ADDENDUM

Project: Science Building Research Wing Expansion

Project No. 03049

Addendum: No. 1

<p>1000 Massachusetts Avenue Cambridge, MA 02138</p>	UNIVERSITY OF SOUTHERN MAINE PORTLAND CAMPUS PORTLAND, MAINE Science Building Research Wing Expansion 70 FALMOUTH STREET PORTLAND, ME 04104	DATE April 28, 2004	SKA-1
	Roof Edge at Curtain wall Pop-up Revised Detail 3/A1.6	SCALE 1-1/2" = 1'-0"

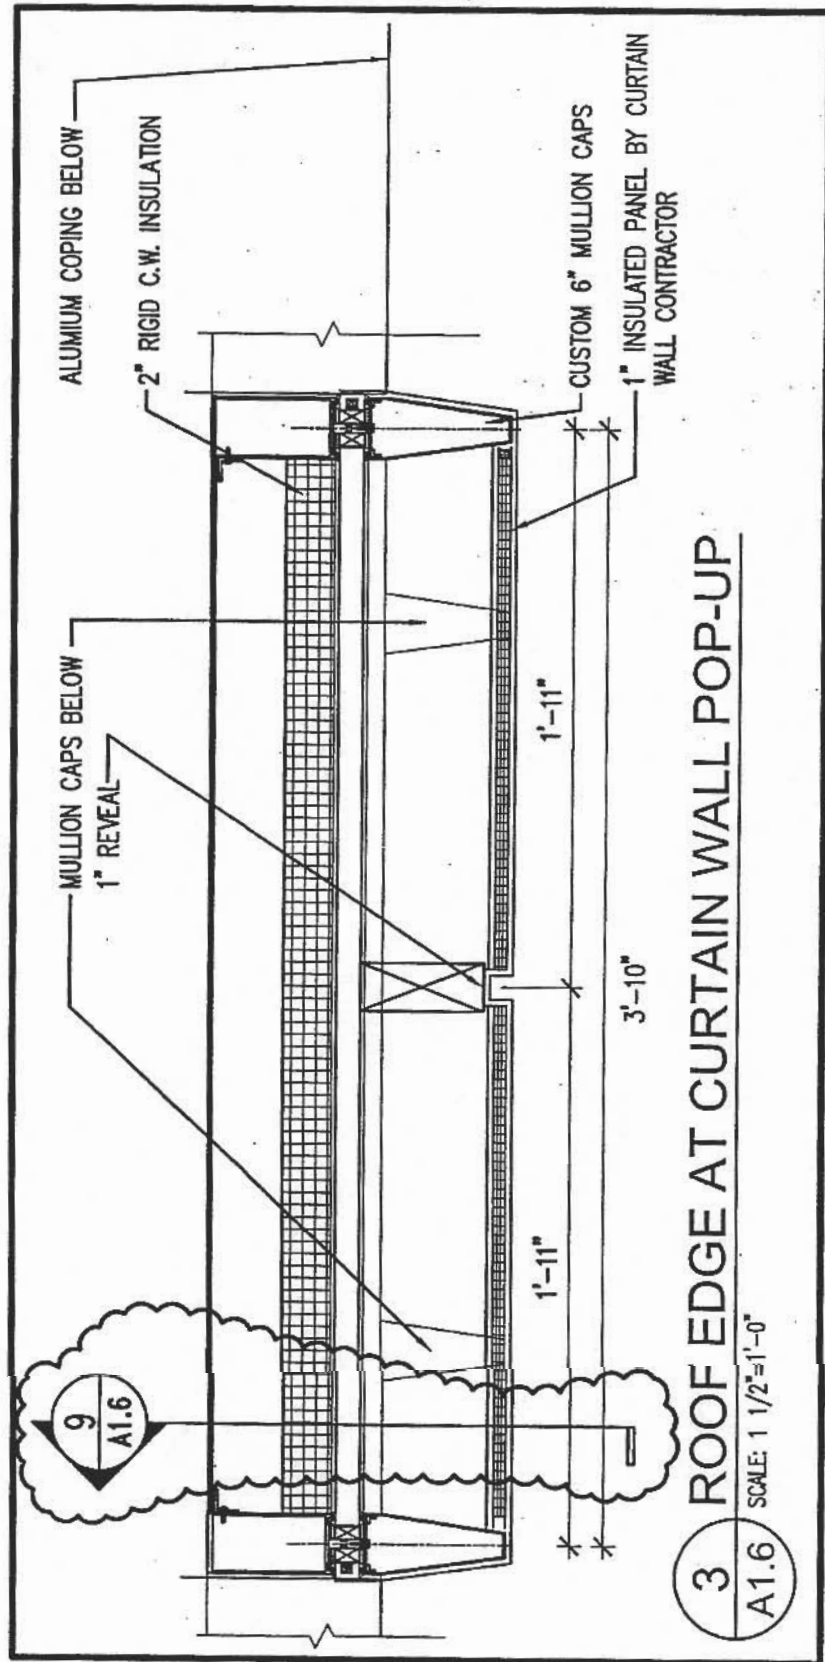
1. Add detail key to detail 3/A1.6 as shown on sketch SKA-1.
2. Add detail key to detail 6/A1.6 as shown on sketch SKA-2.
3. Add detail key to detail 7/A1.6 as shown on sketch SKA-3.
4. Add new detail 8/A1.6 as shown on sketch SKA-4.
5. Add new detail 9/A1.6 as shown on sketch SKA-5.

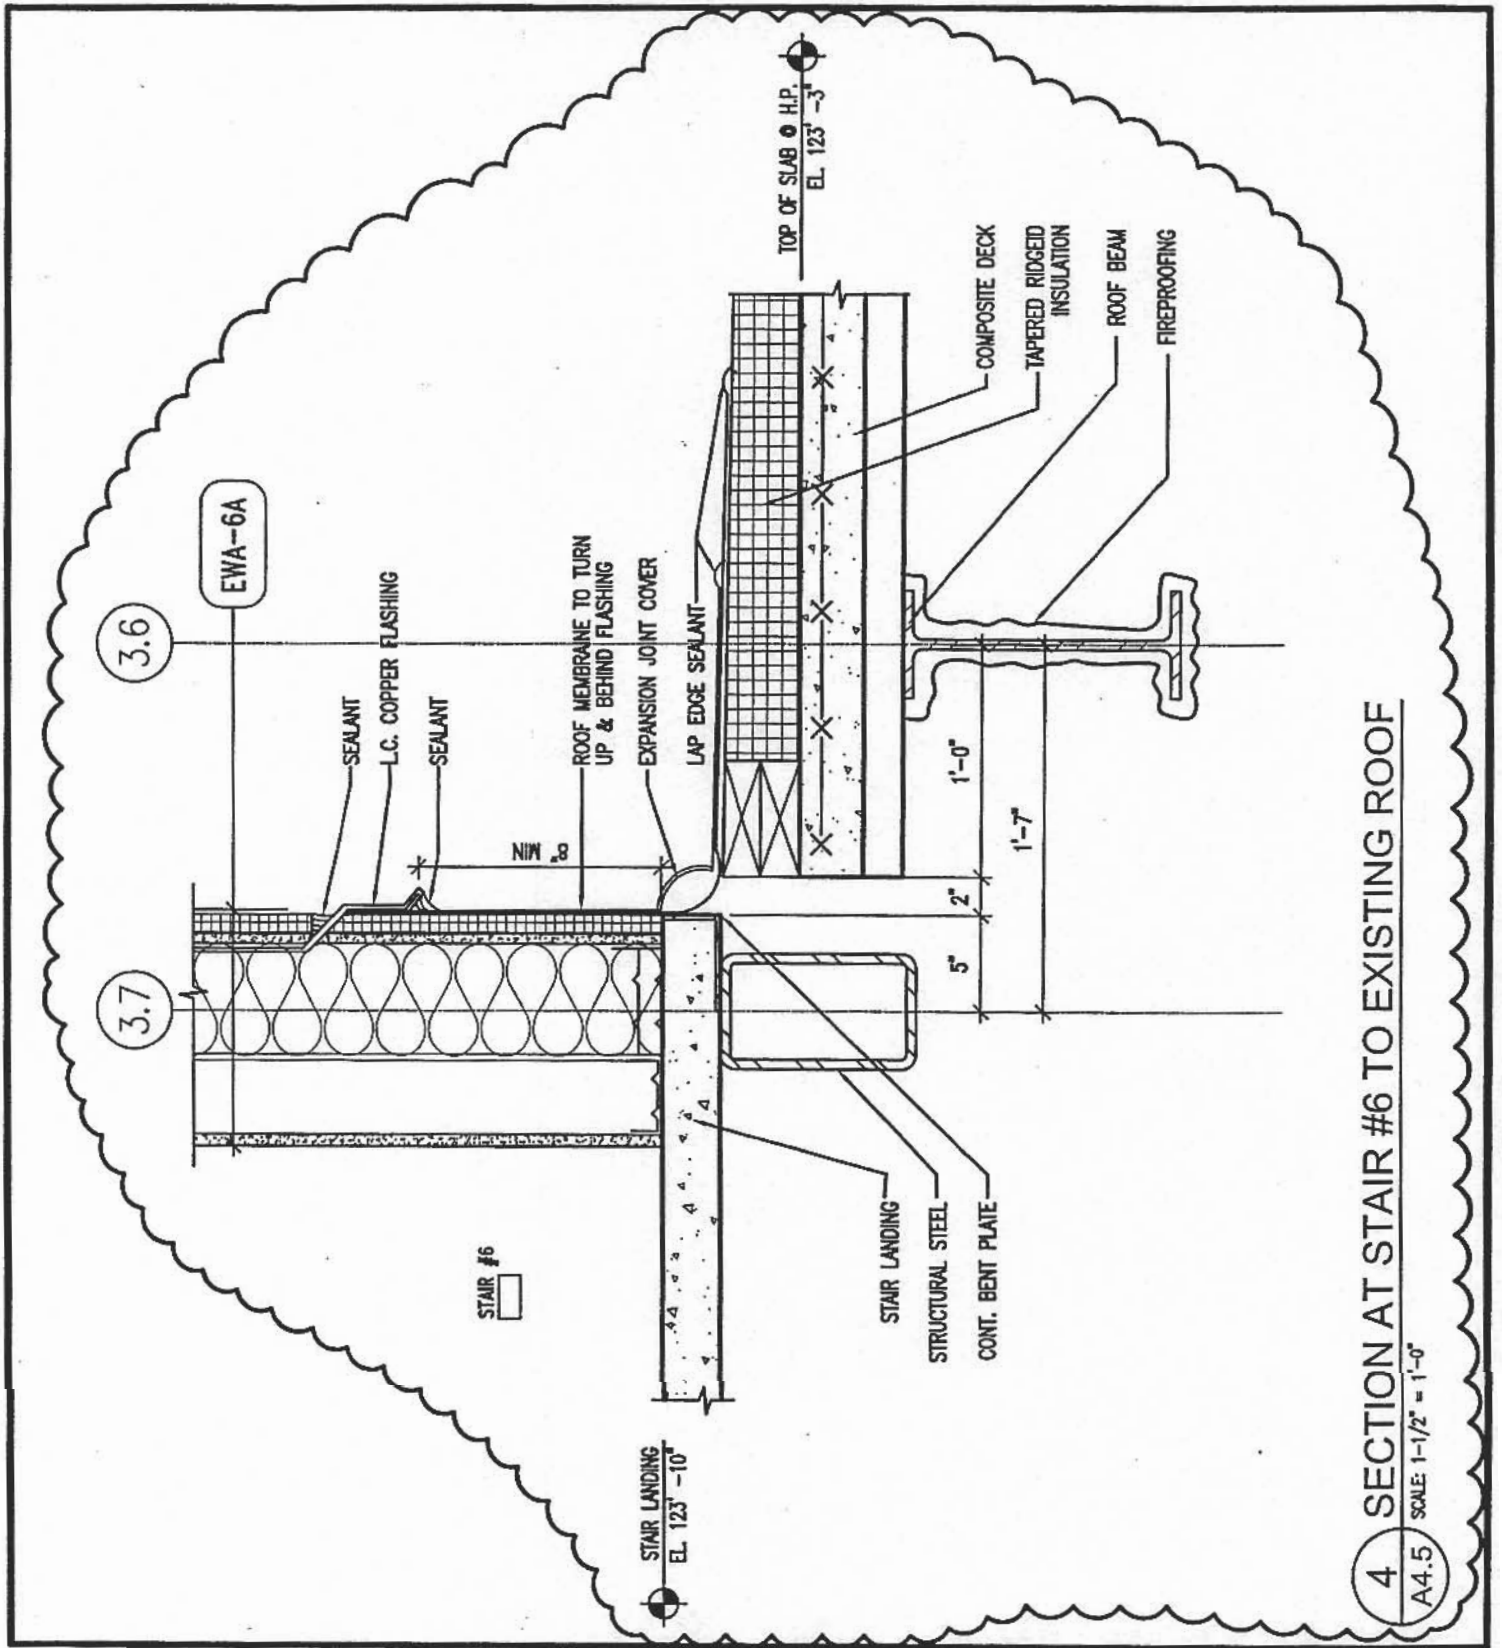
1. Add new detail 4/A4.5 showing flashing and expansion joint at intersection of Stair #6 to roof, as shown on sketch SKA-6.
2. Add new detail 5/A4.5 showing flashing, expansion joint and threshold at door #601, as shown on sketch SKA-7.

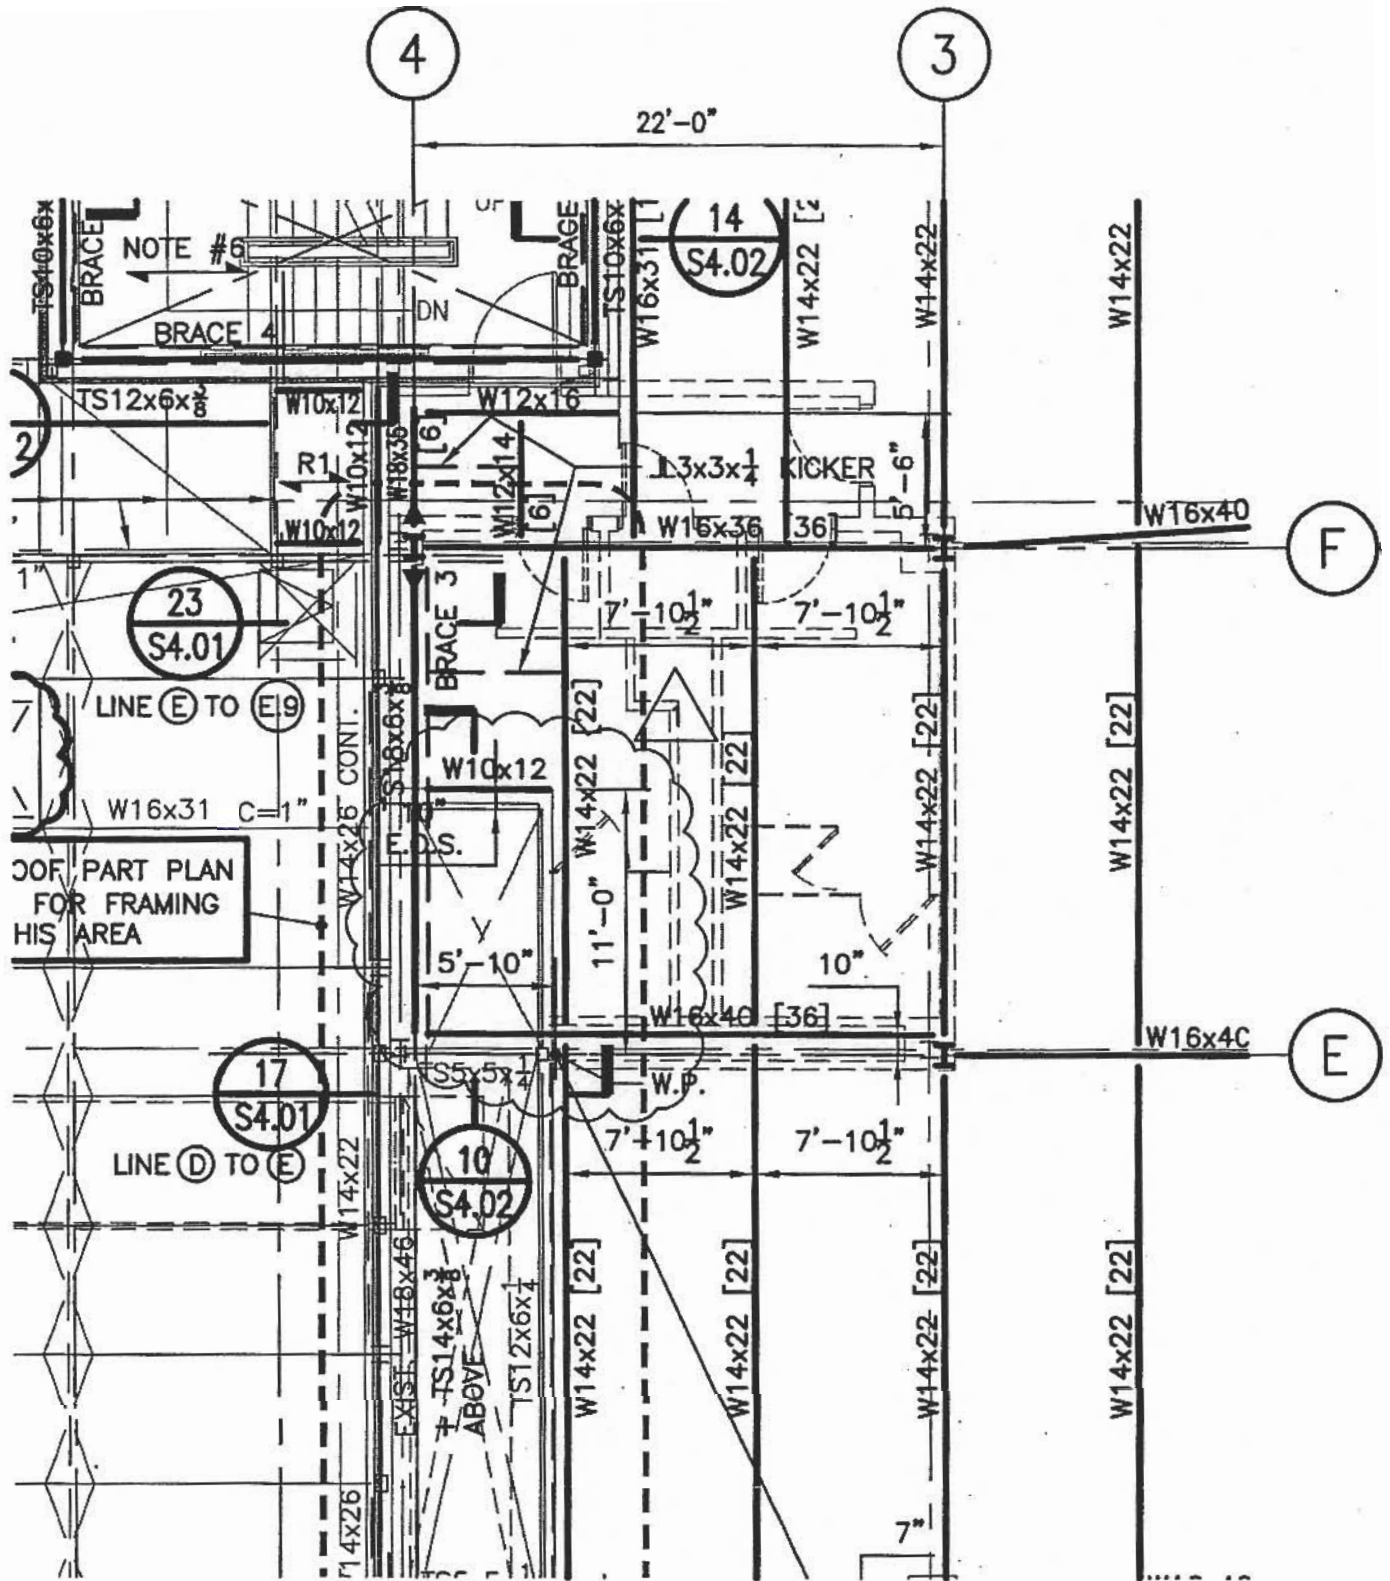
1. Add new detail 17/A4.4 showing typical framing of stair landing at Stair #6 exterior wall, as shown on sketch SKA-8.

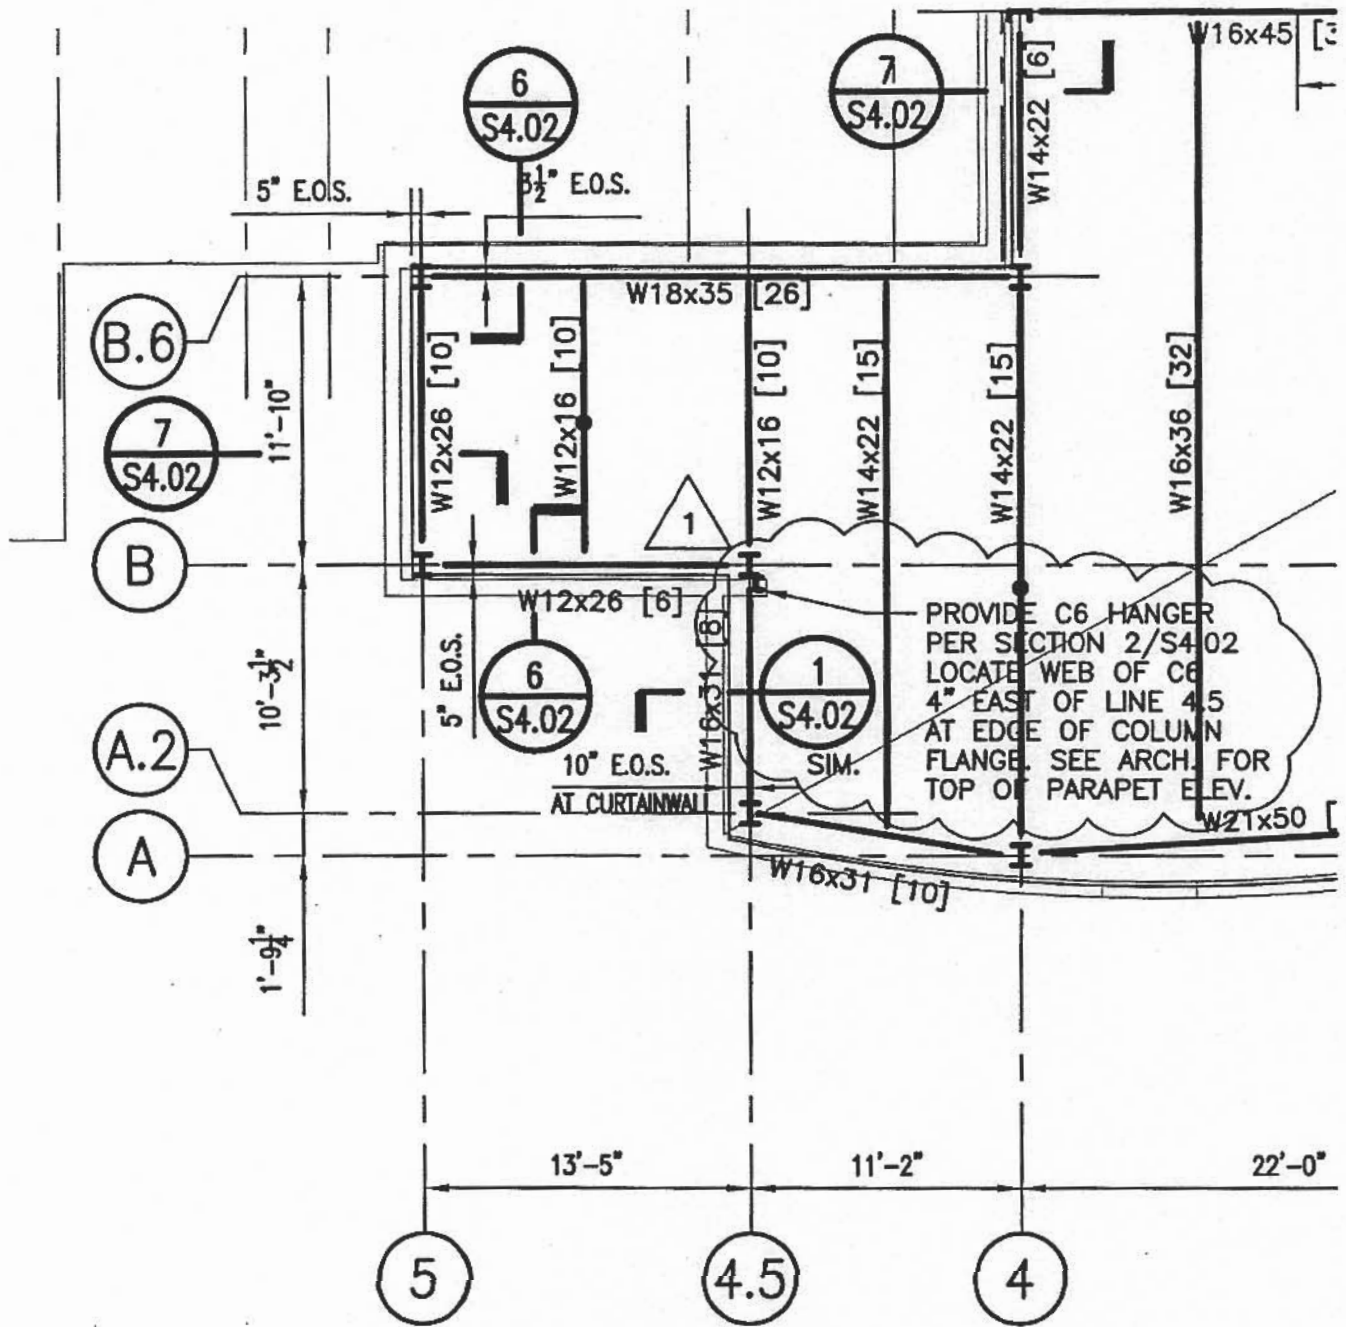
1. Provide additional C6 Hangers for extended roof parapet support as shown on sketches ADD1/SKS-4 and ADD-1/SKS-5.
2. At Stair No. 6, make the top of the steel tubes at the exterior/perimeter of the stair tower equal to 123-7".

PROVIDE C6 HANGER
 PER SECTION 2/S4.02
 LOCATE WEB OF C6
 4" EAST OF LINE 4.5
 AT EDGE OF COLUMN
 FLANGE. SEE ARCH. FOR
 TOP OF PARAPET ELEV.

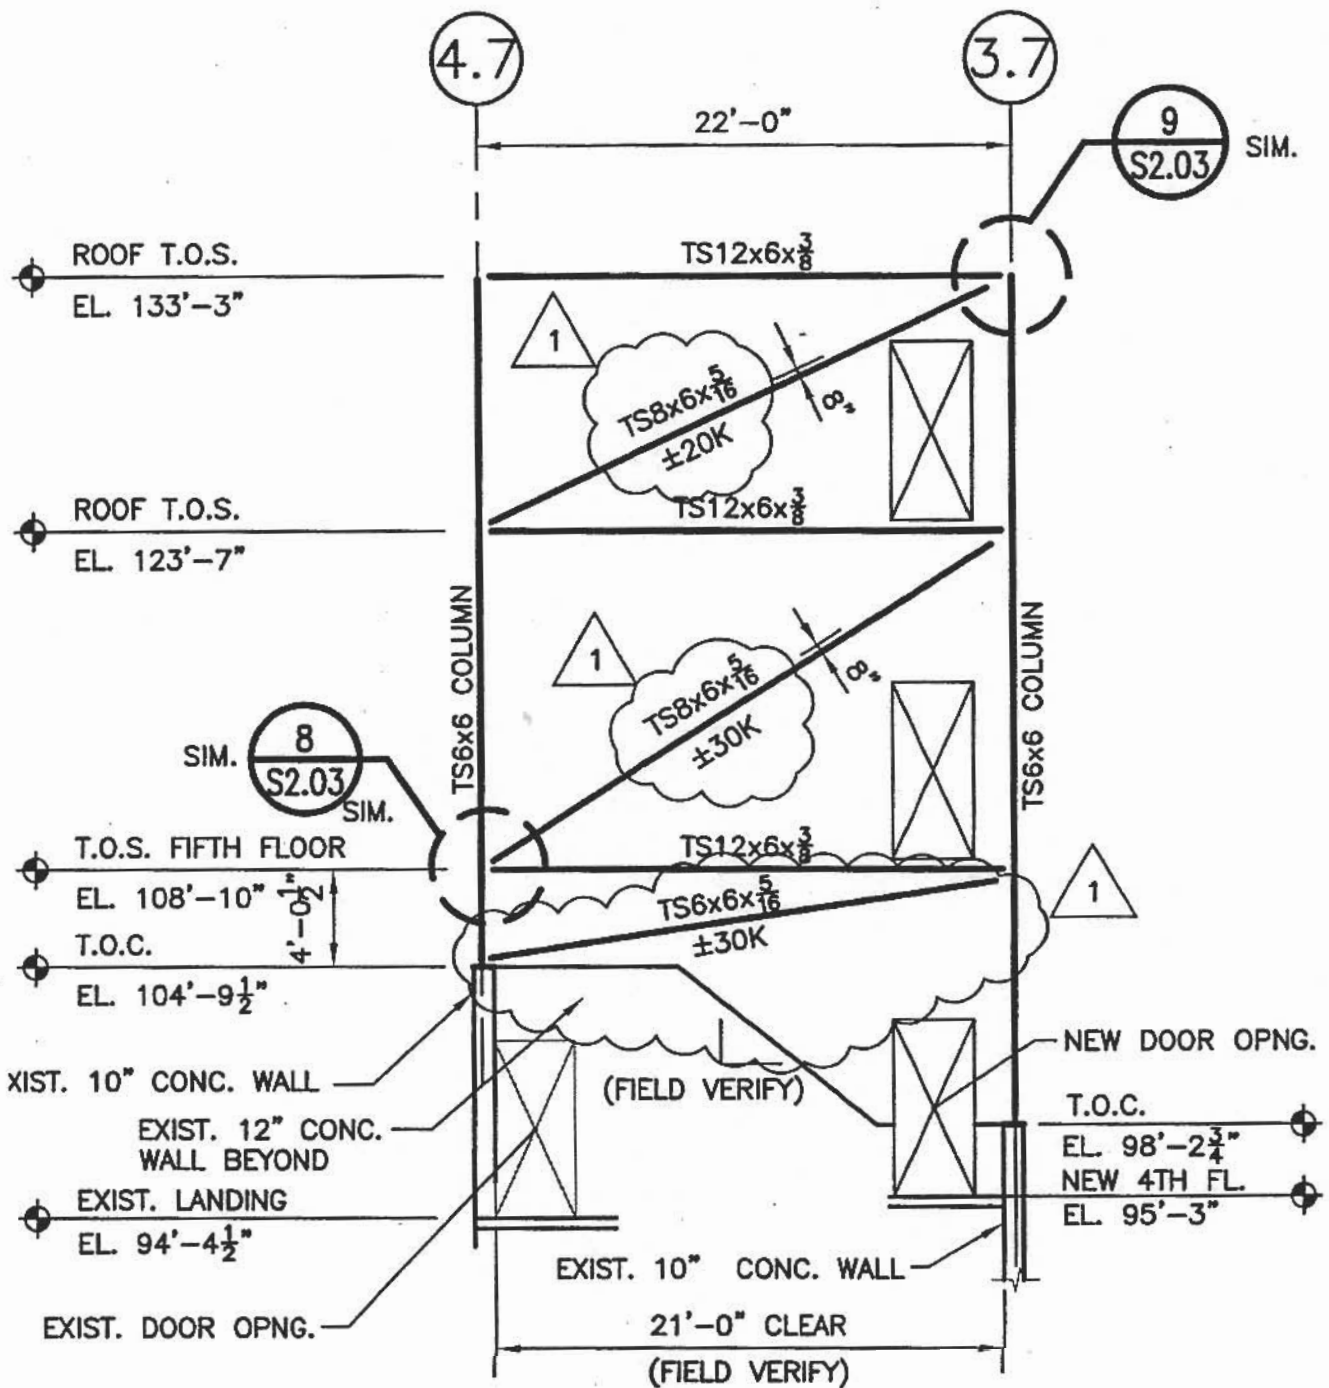
1. Revise Brace Frame no. 7 as shown on sketch ADD-1/SKS-6.
2. Revise the top of steel elevation at the roof level at Braces 4; 5, 6, and 7.

NOTE:
 CHANGE BRACE NO. 4 INDICATED ON LINE F.3
 ON THE PLANS TO BRACE NO. 7 SHOWN HERE.
